Proposed Changes to IEEE802.11d1

Figure 3.1 - Construction of the SDE_PDU

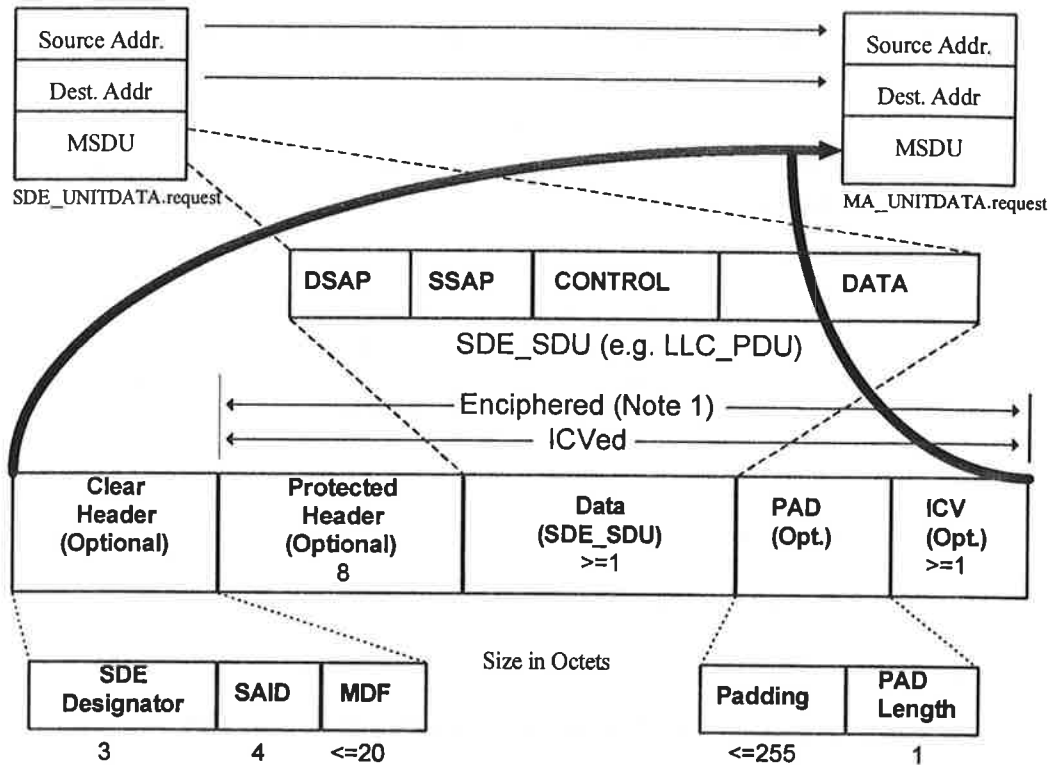
Replace existing Figure 3-1 with the figure below. This is a updated figure provided by 802.10 which I believe is easier to understand and more accurate.

Figure 3-2: SDE management architecture

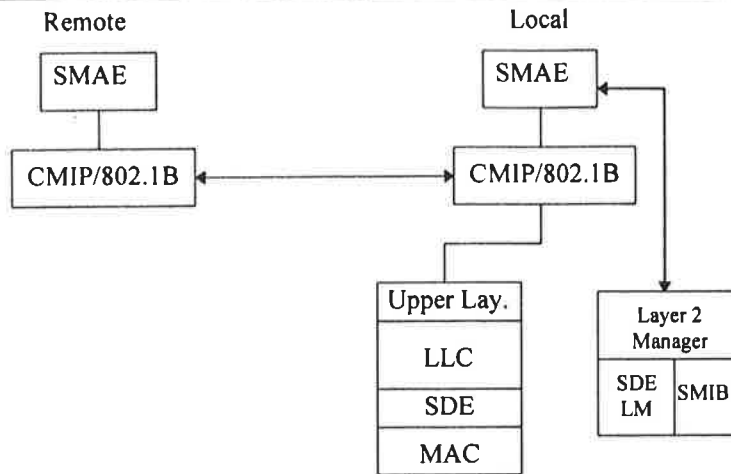
Add the following paragraph at the end of paragraph 3.1.1.3:

The Layer 2 security services provided by the SDE rely on information from non-Layer 2 management or system entities. Management entities communicate the information to the SDE entity through a Security Management Information Base (SMIB). The implementation of the SMIB is a local issue; however, IEEE 802.10f, SDE Sublayer Management, provides information on the managed object classes and attributes. The SMIB provides the interface between the local System Management Application Entity (SMAE) and the LM of the protocol stack. This is illustrated in Figure 3-2 (will require renumbering of the section 3 figures):

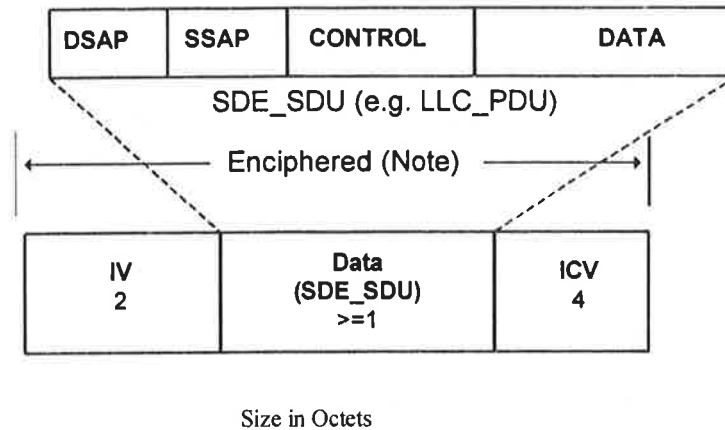
Change second paragraph to read;

Data confidentiality depends on an external key management service to authenticate users and distribute data enciphering/deciphering keys. P802.11 specifically recommends against running an 802.11 with ~~confidentiality/privacy~~ but without authentication. While this combination is possible, it leaves the system open to significant security threats.
